ADDENDUM NO. 2

DPW Project #2023256

April 30, 2024

**DPW/UI – Ag Science Building HVAC Phase Two
University of Idaho
Moscow, Idaho**

SHEET
T8.01

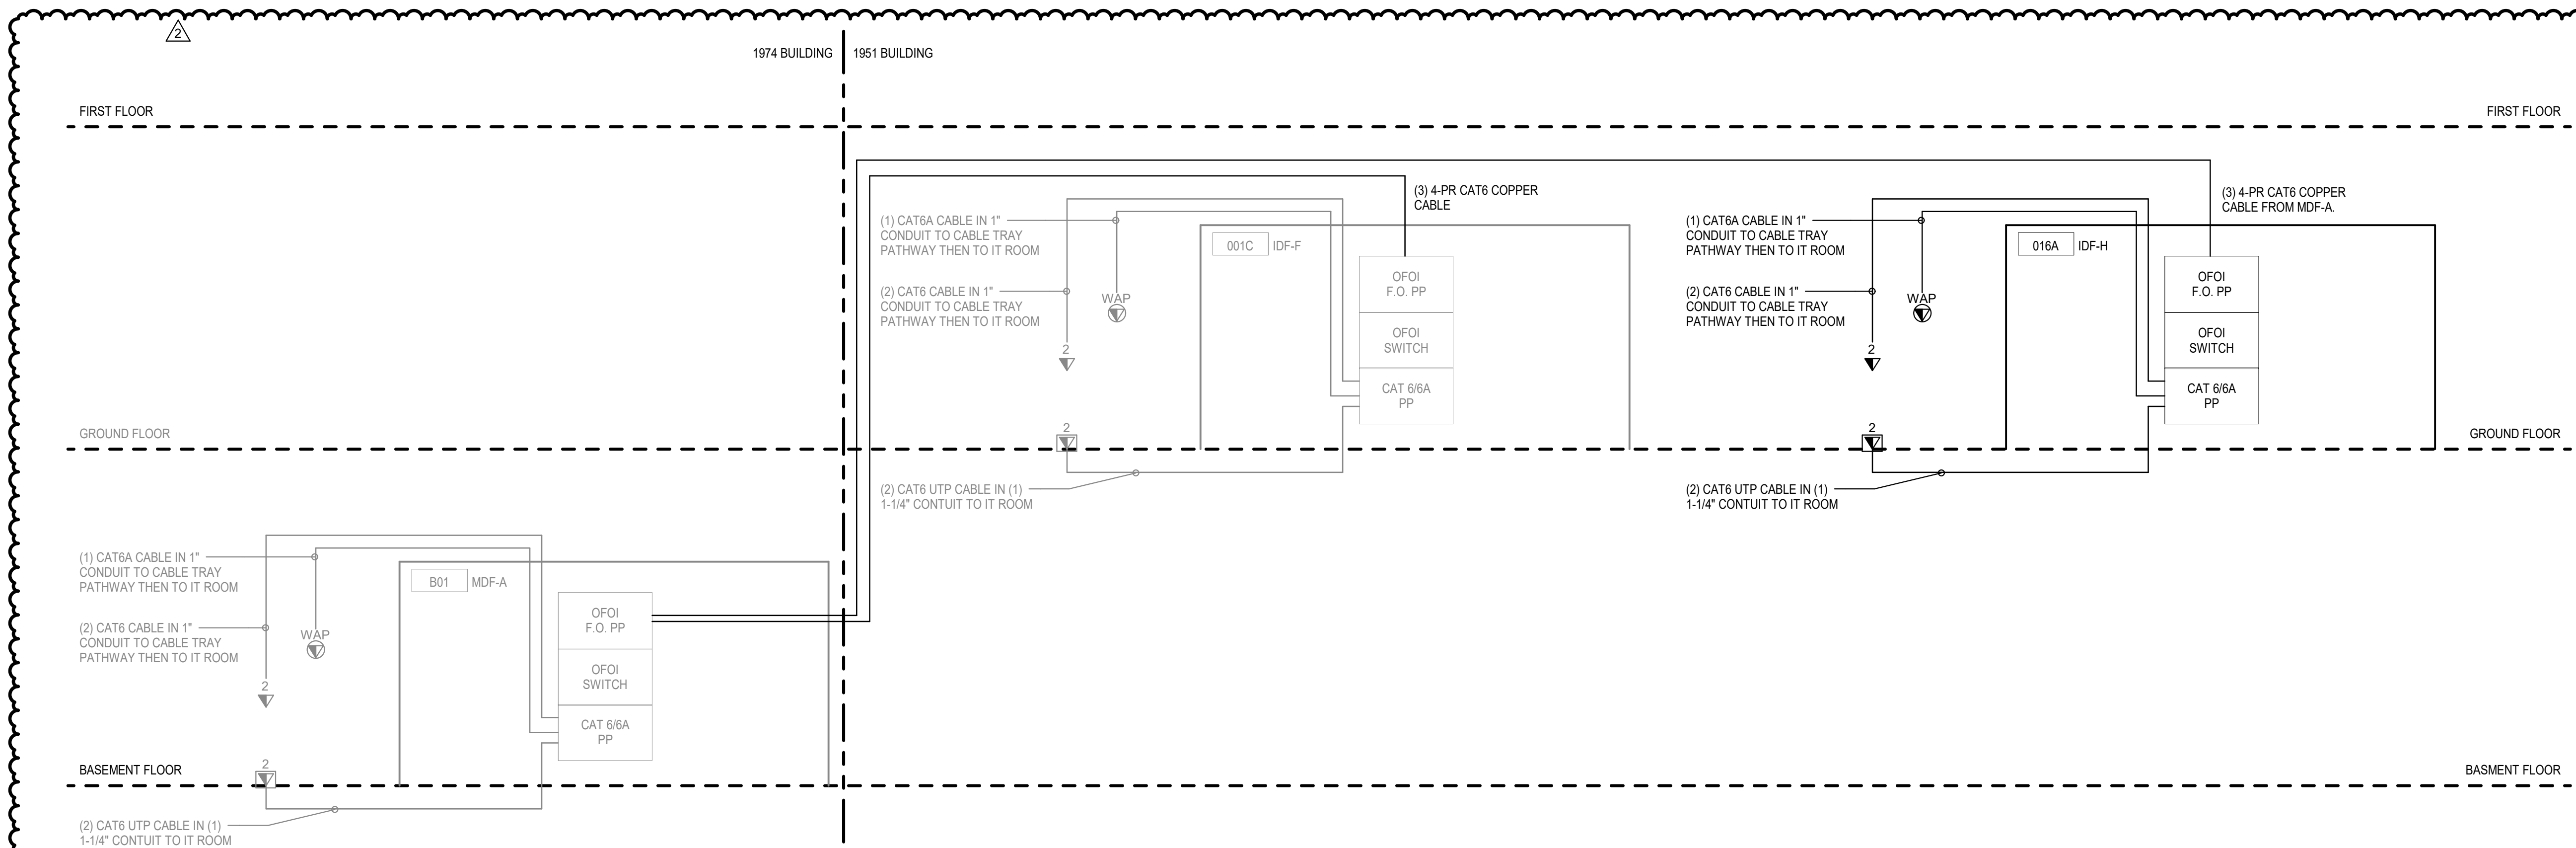
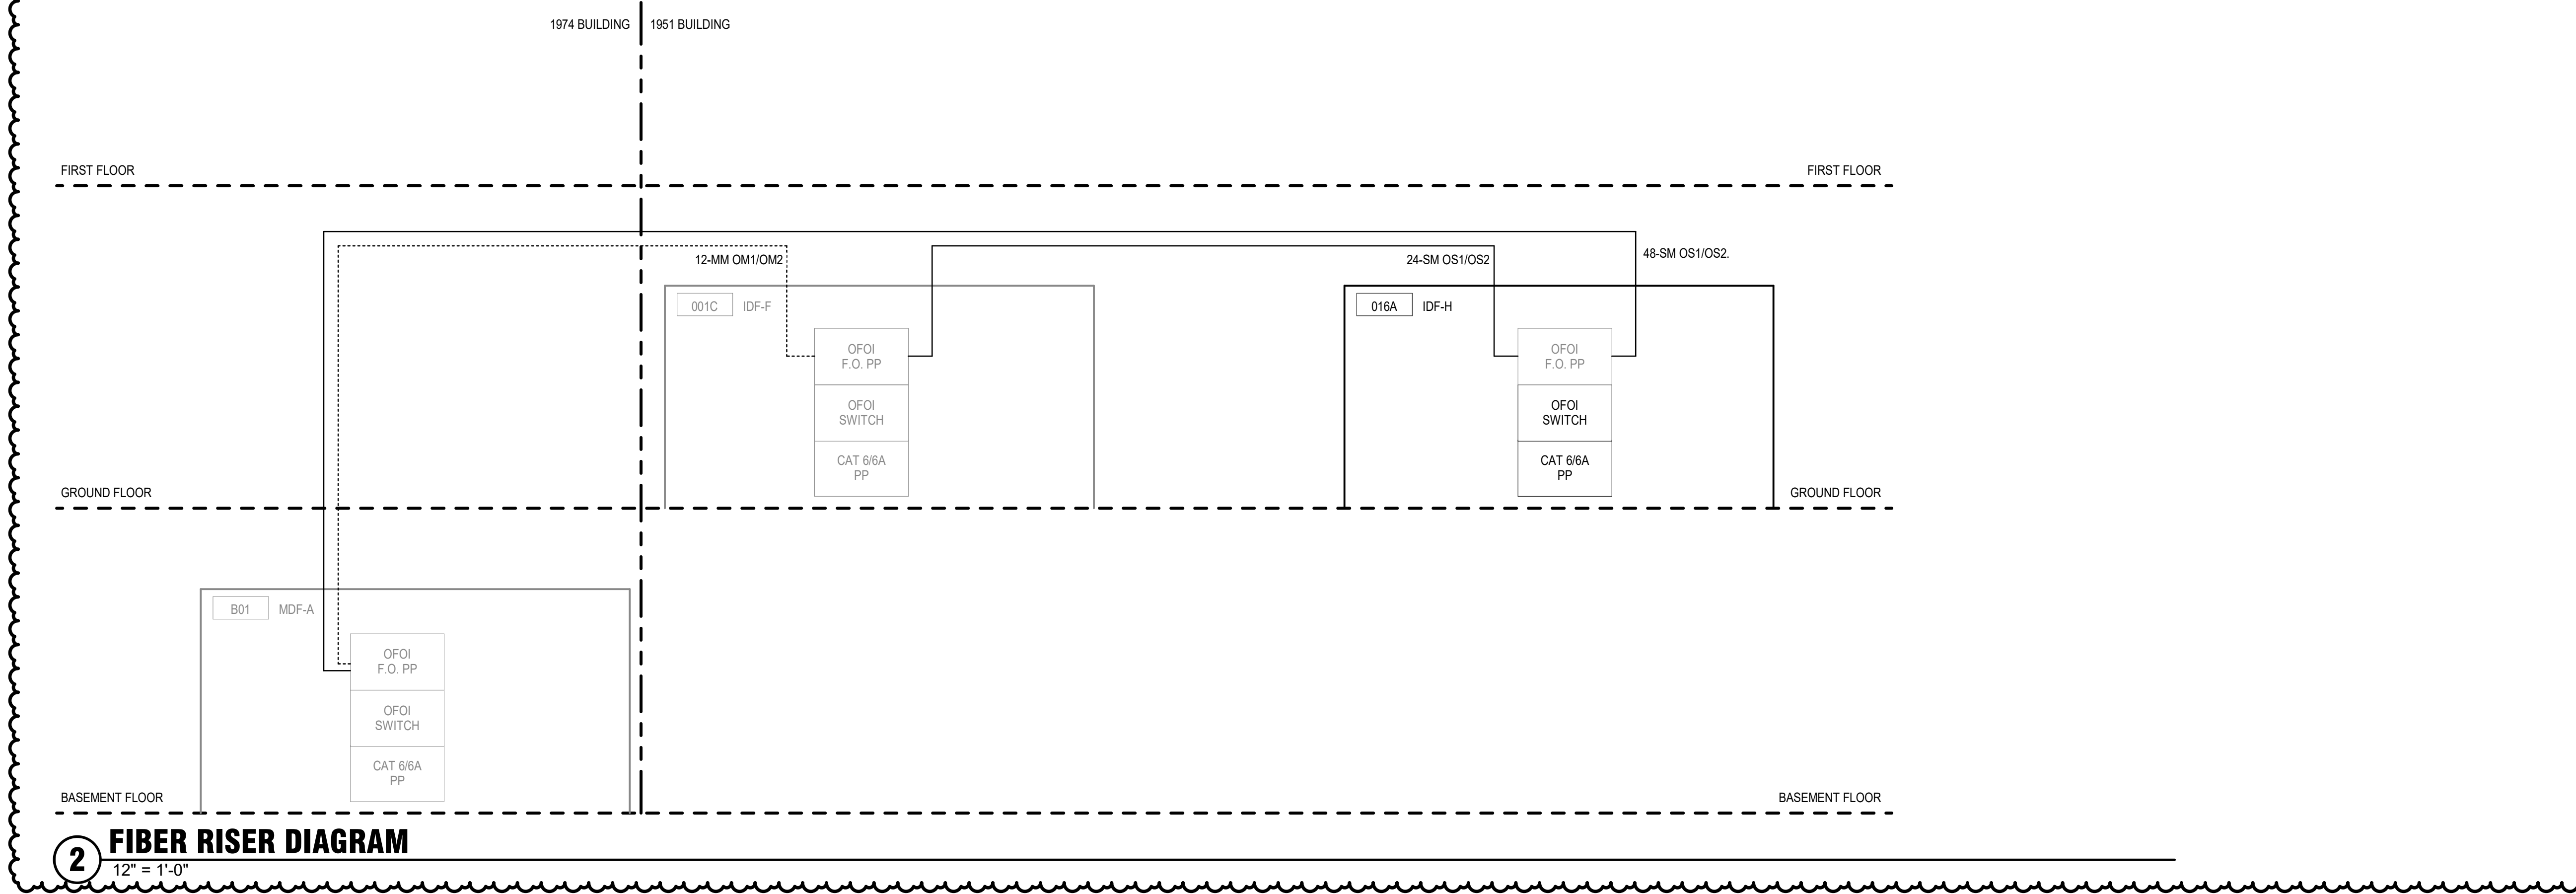
ADDITION: See attached added Sheet T8.01, including added copper and fiber riser diagrams.

1 GROUNDING RISER DIAGRAM
12" = 1'-0"

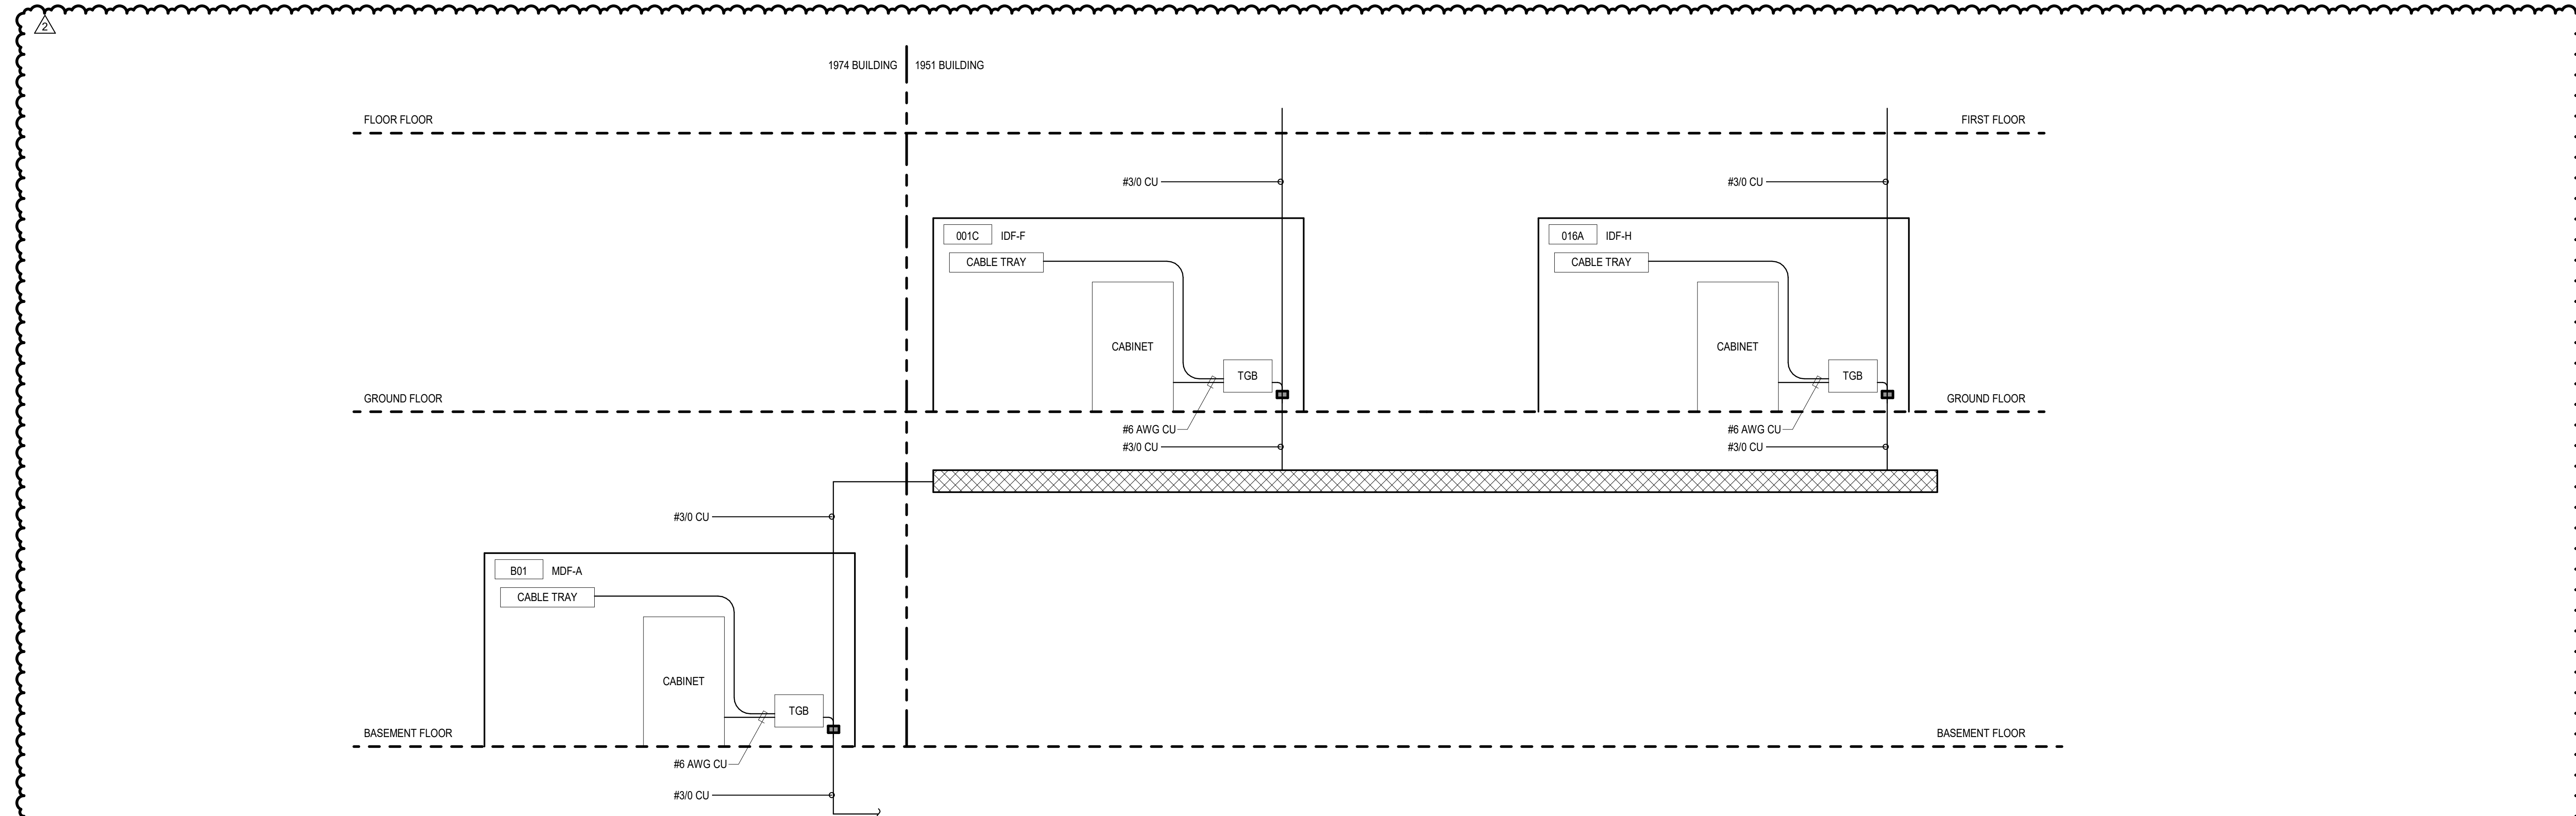
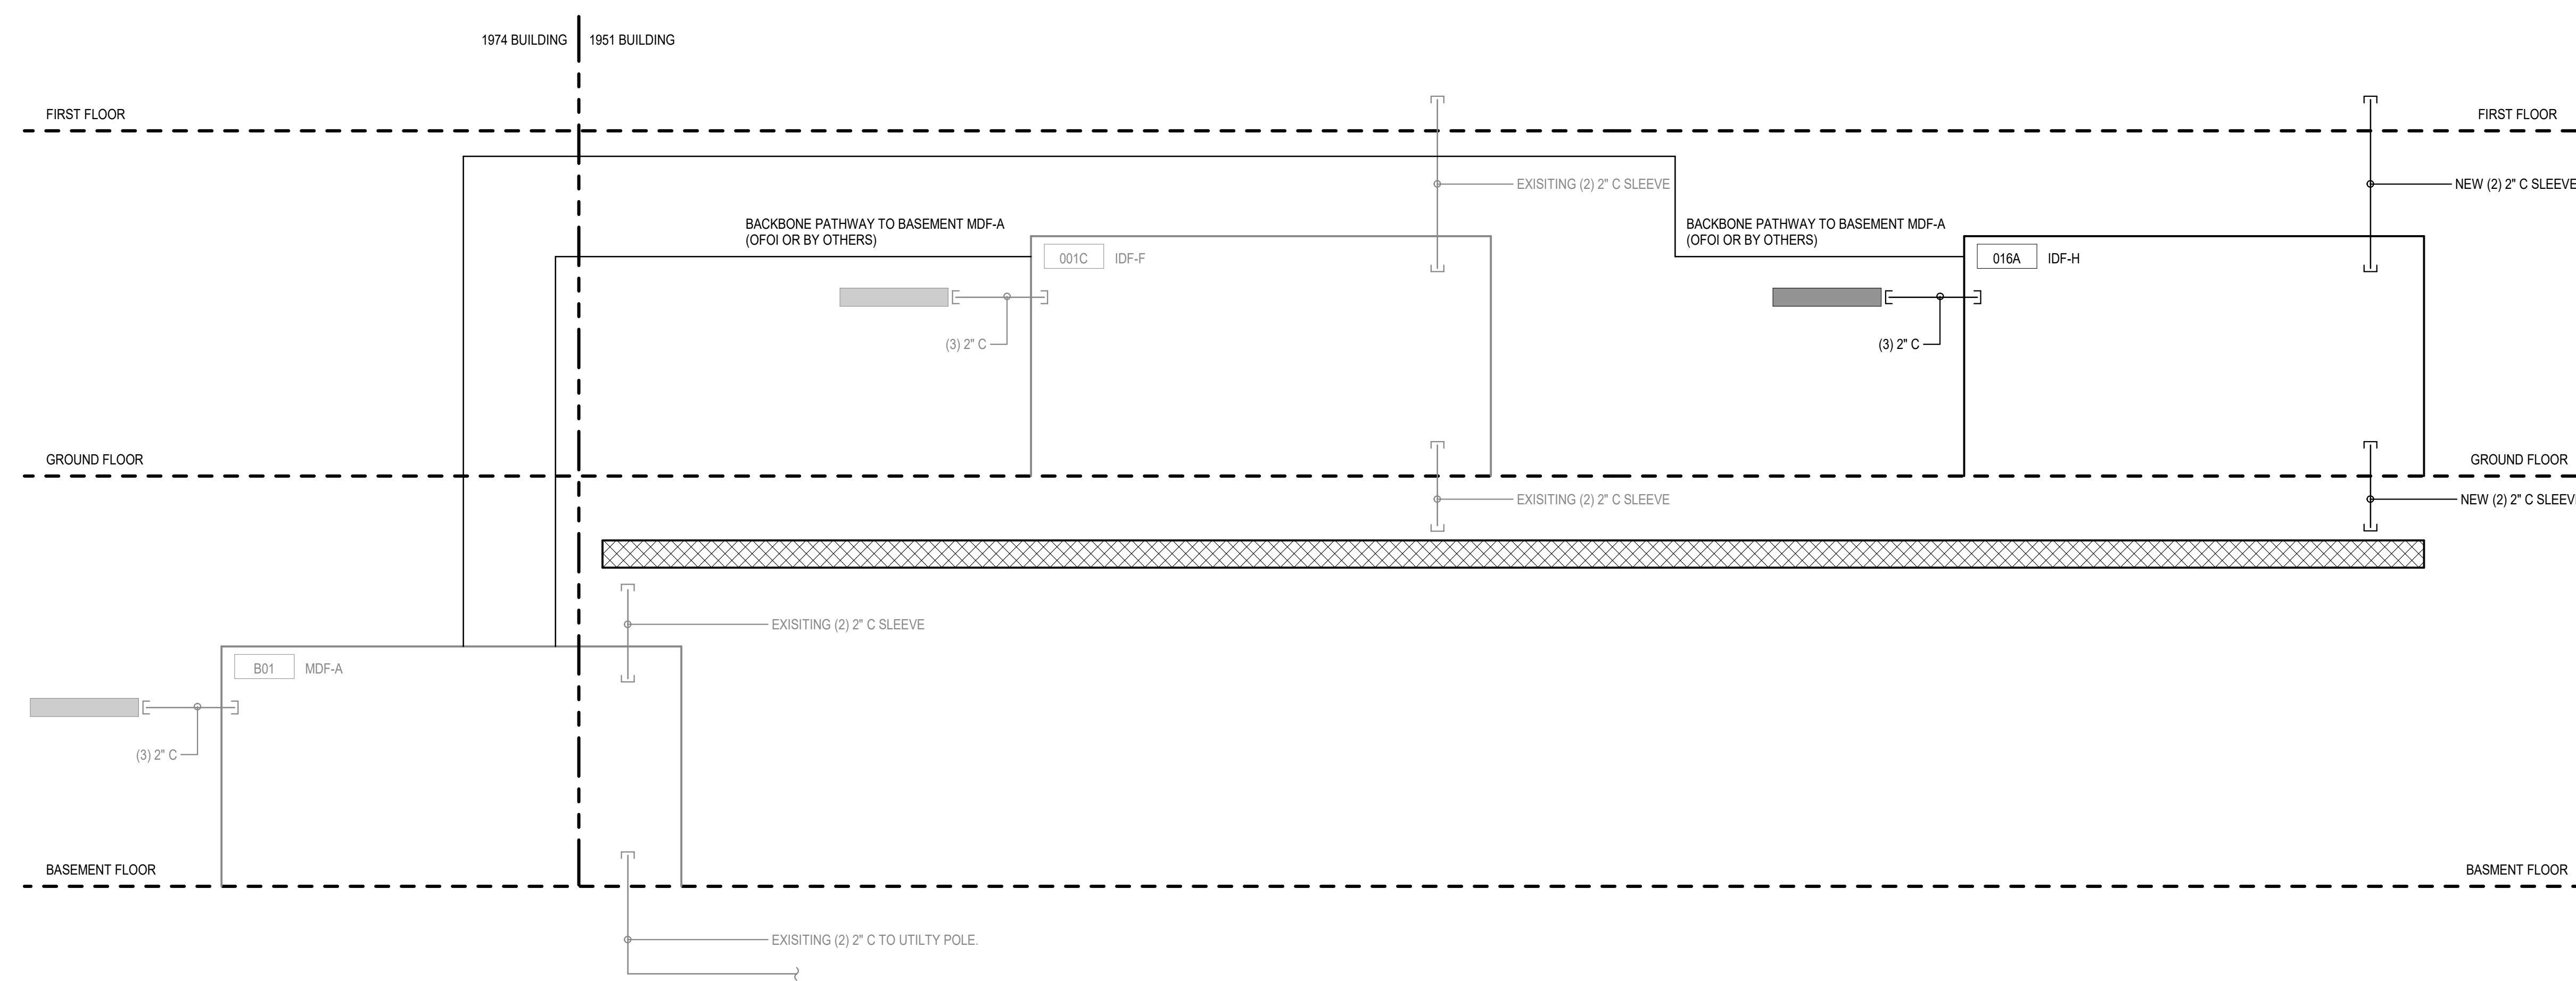
ADDITION: See attached added Sheet T8.02, including added grounding and pathways riser diagrams.
